Village of Beverly Hills Planning Commission Meeting Wednesday, June 24, 2020 Municipal Building 18500 W. 13 Mile Rd. 7:30 p.m.

AGENDA

Attention:	Erin LaPere, Planning and Zoning Administrator
Subject:	Michigan Orthopedic Surgeons – Sign application review
Location:	17877 14 Mile Road – south side of 14 Mile, east of Southfield Road
Zoning:	O-1 Office District

SITE PLAN

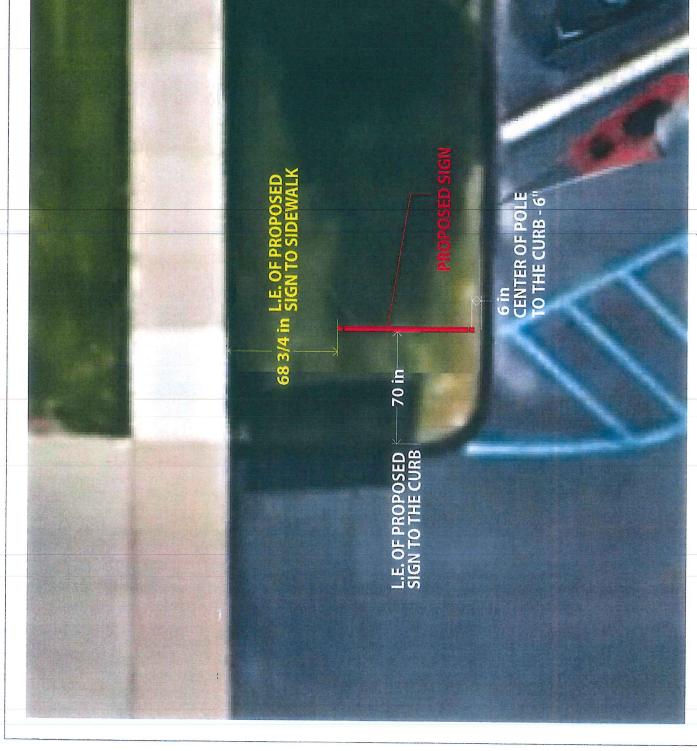
At the Village's request, we have reviewed the submittal requesting a new ground sign for Michigan Orthopedic Surgeons at 17877 14 Mile Road.

Permitted	Proposed	Comments
Area	30 SF maximum (ground)	29.25 SF	In compliance
Number of signs	2 types	1 ground sign	In compliance
Height	Max 8' (ground)	6'	In compliance
Illumination	Back-lit, indirect, external or no more than 30% internal	No lighting proposed	In compliance
Setback	4' minimum	Approximately 3-4'	Setback/placement is consistent w/ ZBA action on 6/8/20
Landscaping	200 SF min. area w/ live ground cover	More than 200 SF covered w/ grass	In compliance
Color scheme	No more than 3 colors	Blue, green, and black (w/ white background)	In compliance
Lettering types	2 (max.)	1	In compliance

Given the setback variance granted by ZBA, the proposed ground sign complies with the requirements of Section 22.32 Signs of the Village Zoning Ordinance.
